Administrative Change Approval Form Order

East Port Water Reclamation Facility Expansion

CCU Change Order Request
East Port WRF Expansion - Poole and Kent
Change Order #4

Subject: PCO 30- Changes to the effluent boxes on Clarifier #3 & #4
P&K PCO No. 30

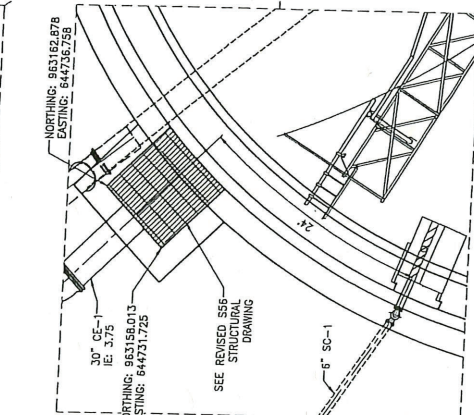
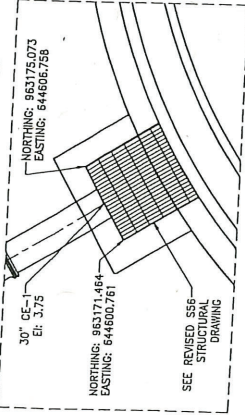
In regards to the 30" effluent lines at Clarifiers 3 & 4, PK potholed to expose both "connection" points. Neither are what is indicated on the drawings. Clarifier #3, the tee is orientated differently from what is shown. Clarifier #4, there is no tie in point, we exposed just pipe, no tee or fittings to connect to. Please see the attached drawing for reference. This is an active line with no way to isolate. For Clarifier #4, advise on how to tie into this line. For Clarifier #3, please advise on how to revise the piping to make the existing connection work or supply us on degrees and angles to rotate the clarifier effluent box to make the connection work.

- Lastly, there also is no 42" x 30" reducer on this line where shown. Potentially 3 or 4 30" effluent lines off the clarifiers will be tying into the same 30" common pipe. Please confirm this is acceptable with flow calculations.

is Described Below or in the Attached: Please refer to the attached PDF pages 2 and 3 for the revised configuration.
The clarifier outfall boxes will be rotated and approximately 3 feet deeper to accommodate the vertical and horizontal alignment to the existing pipe Tie-In locations

NOTES: 1. An additional 30" - 45 degree bend will be required as part of this revision.

2. The Scum Pit box orientation will need to be adjusted as shown. A formal PCM will be posted.
